**ADDRESS: 1730 WHARTON ST**

Proposal: Legalize windows, with modifications

Review Requested: Final Approval

In April 2025, the Architectural Committee reviewed an application for legalization and recommended denial. The application was continued several months to allow the applicant to work on a revised proposal, which is being presented on the following pages marked as "Revised." This revised application requests permission to retain most of the aluminum windows but proposes modifications within some masonry openings to attempt to better fill the openings like the historic windows had. The revised application also proposes a new design within the monumental opening on Wharton Street that is intended to simulate the historic design.

**A200**

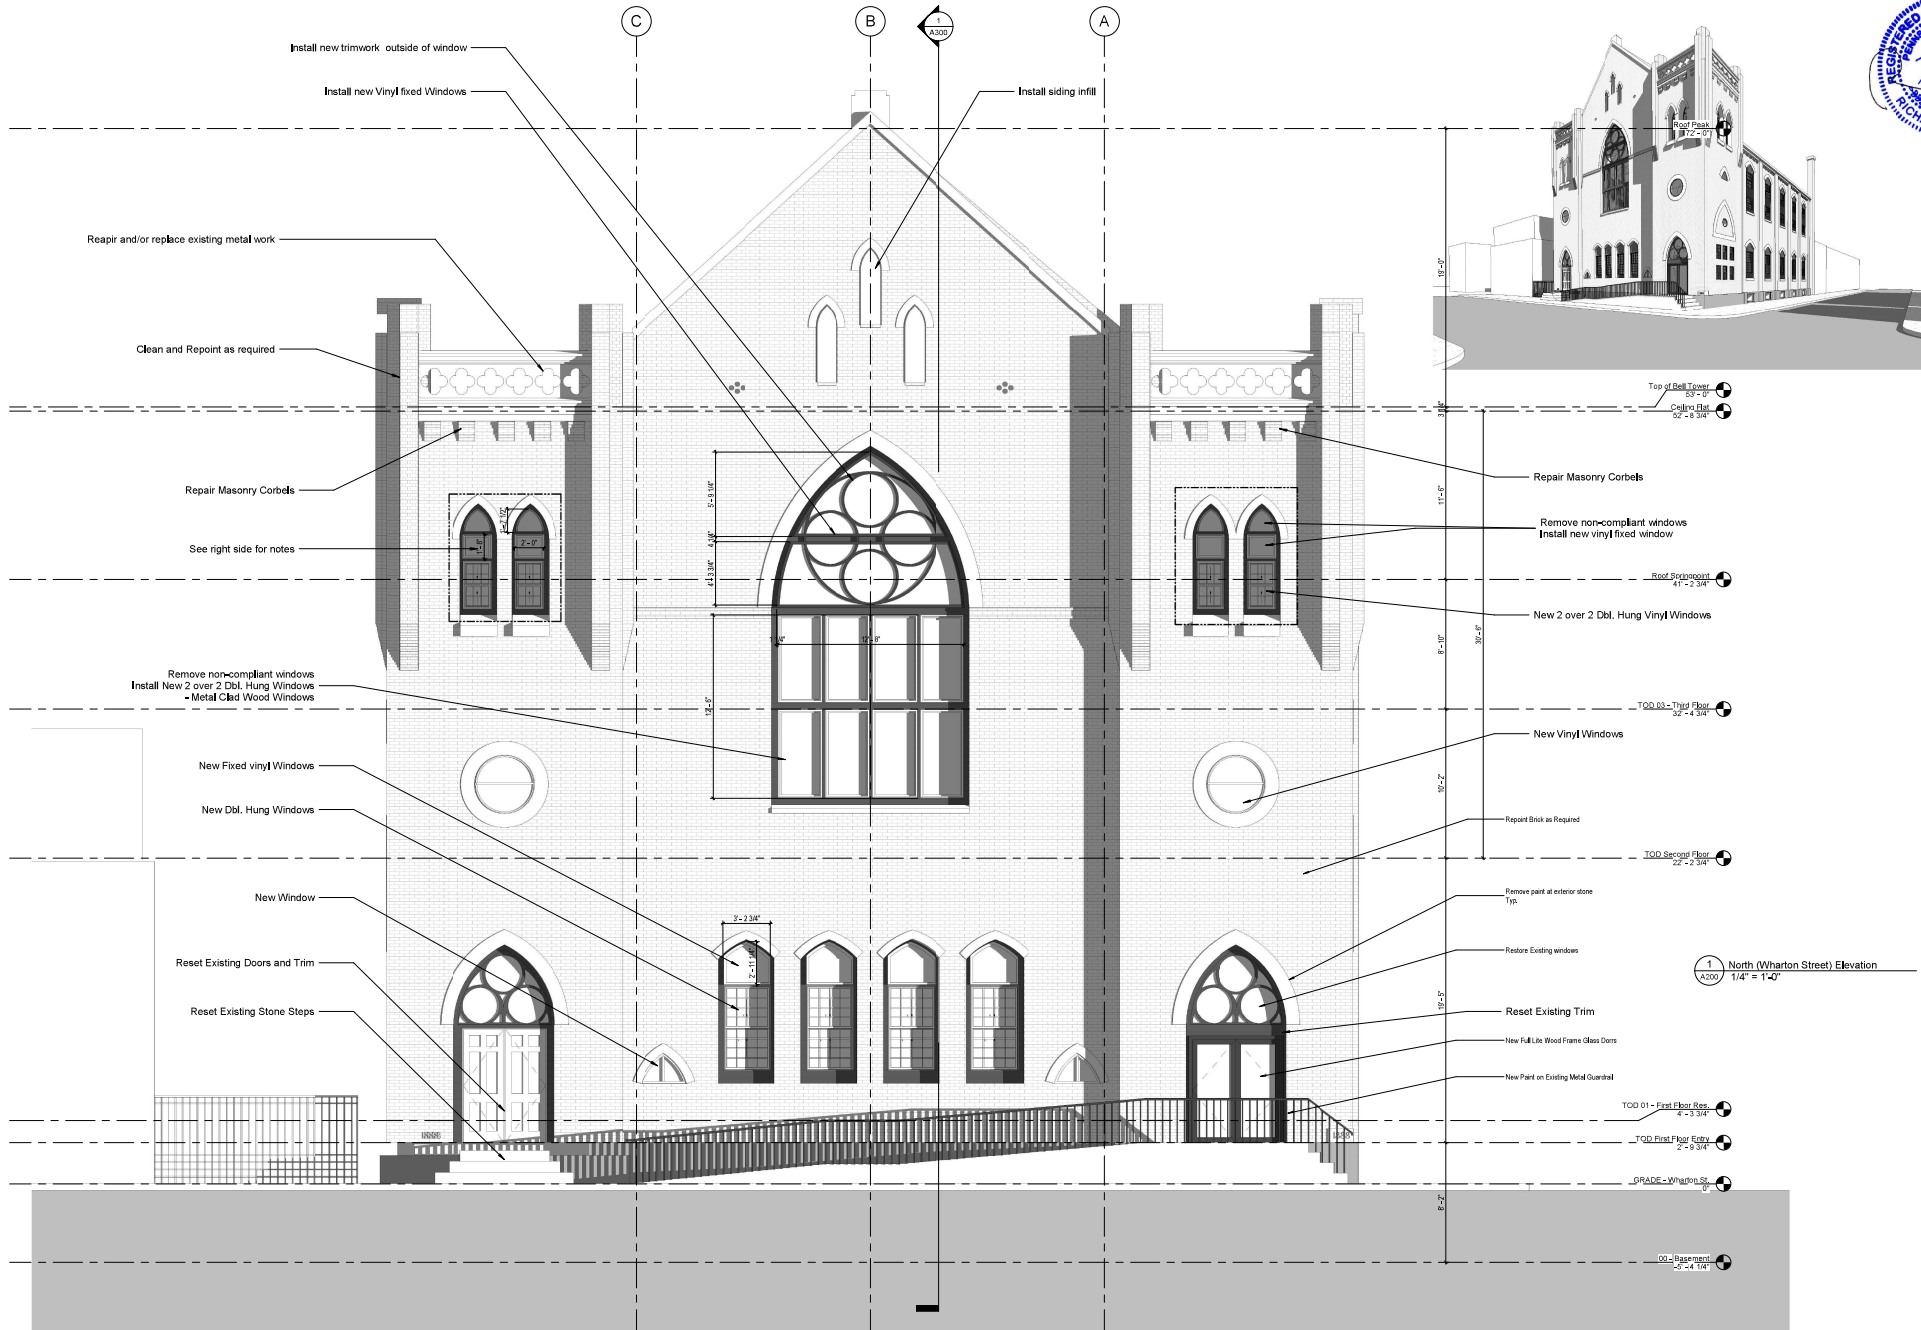
- The new windows, even with proposed modifications, do not match the old in design, color, texture, or materials. This application fails to satisfy Standard 6.

**STAFF RECOMMENDATION:** Denial, pursuant to Standard 6.
